DOCKETED		
Docket Number:	07-AFC-06C	
Project Title:	Carlsbad Energy Center - Compliance	
TN #:	202992	
Document Title:	Data Requests, Set 2 (31-58)	
Description:	N/A	
Filer:	Sabrina Savala	
Organization:	California Energy Commission	
Submitter Role:	Commission Staff	
Submission Date:	8/27/2014 12:36:14 PM	
Docketed Date:	8/27/2014

CARLSBAD ENERGY CENTER PROJECT AMENDMENT (07-AFC-6C) DATA REQUESTS, Set 2 (#31-58)

CULTURAL RESOURCES - DR - FIGURE 1 Carlsbad Energy Center - Project Area of Analysis for Built Environment Resources

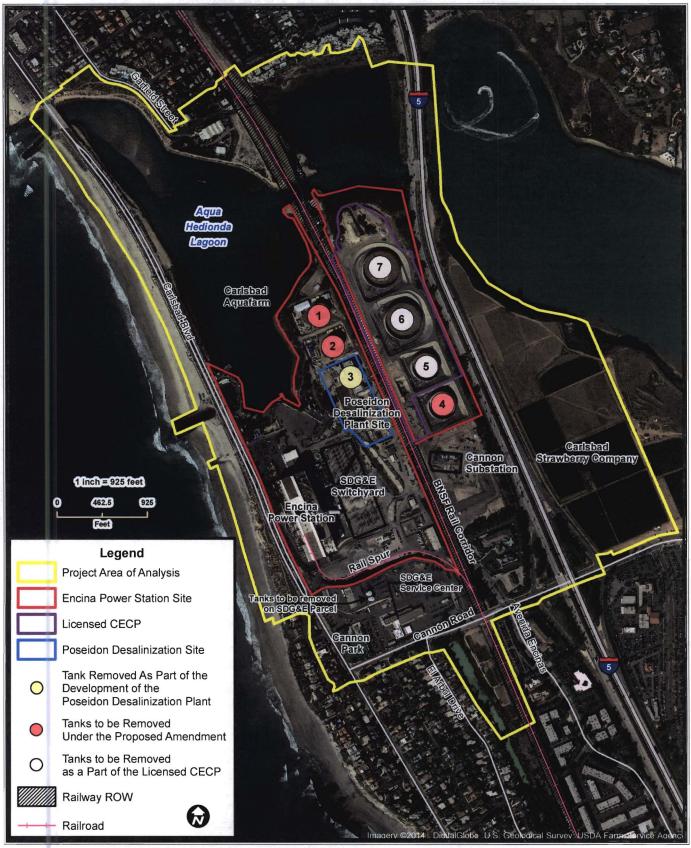
- 36. Please conduct a built-environment cultural resources survey of the areas in which the amendment activities would take place, including the one-parcel boundary established by staff for this PTA (see Figure 1). The survey shall conform to the standards established at Title 20, California Code of Regulations, sections 1704 and 2012, Appendix B(g)(2)(C).
